Standard Hydraulic Power Units YP Pack (1.5 kW)

Notice of Model Change

The YP Pack will undergo a model change in conjunction with the model change of the 1.5 kW PAL Pump.

■ Selection Chart Comparison

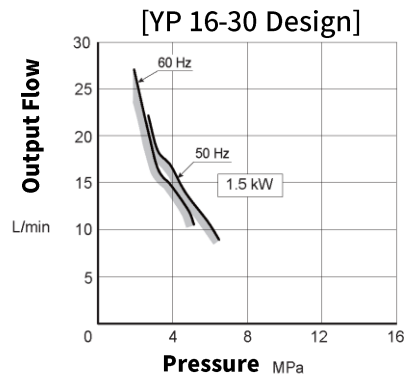
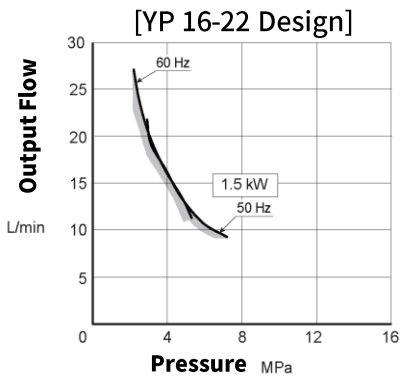
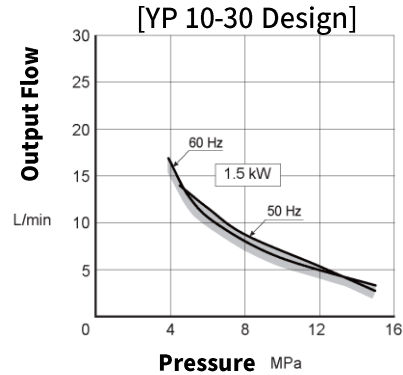
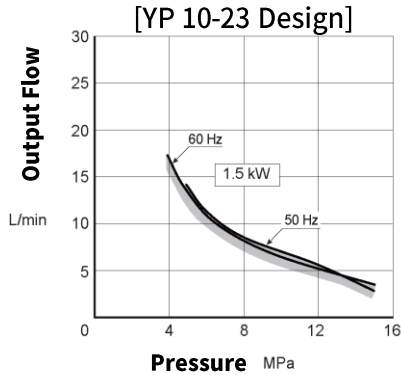
★ Measured under the same conditions for both old and new designs.

■ Tank Oil Temperature Rise Comparison [At Full Cut-Off]

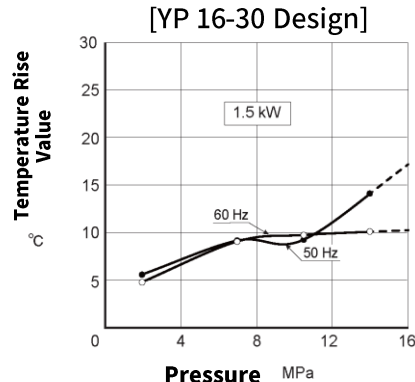
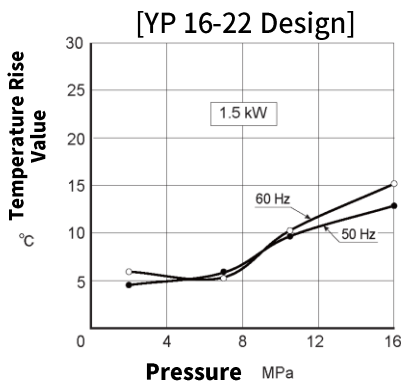
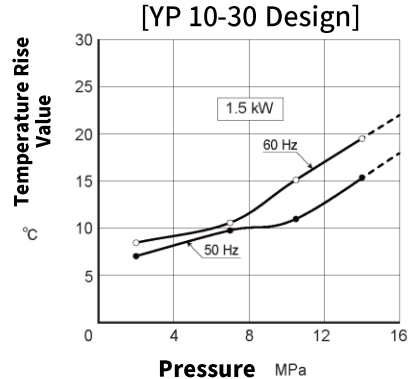
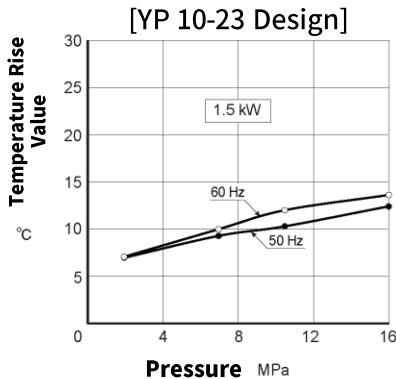
★ Measurements for both designs were taken under the same conditions.
